Avolites Ltd. Engineering Change Notice

Title ART 4000 main card fixing
ECN Number ECN-0118
Equipment All ART 4000 modules until units with production date later
Than May 2000
Author J.B.Toby
Drawing Number
Date 9th May 2000

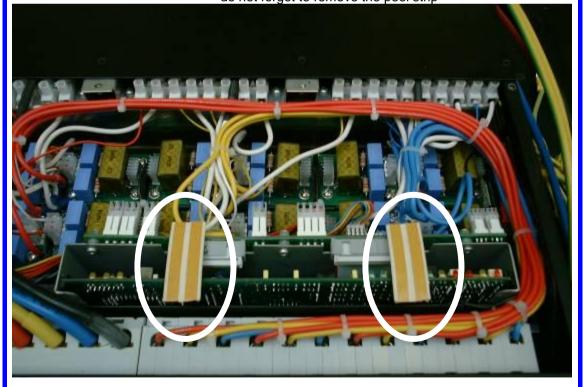
Reason for ECN	The main card can work itself out of the ribbon connectors during transport This may result in poorly starting of the ART 4000
Special Parts required Special Tools required	after being moved. Rubber foam strip set 32-02-9000 (1 set for 1 module) None

Slide the dimmer out of the rack until the slides lock
Remove the front top cover using a size 2 supa drive screwdriver.
place the 2 foam strips on the card as per picture below.
do not forget to remove the peel strip

replace the cover at the breaker side first, and rotate the cover down

Check that both strips have "stuck" to the cover before finally fixing the cover to the dimmer.
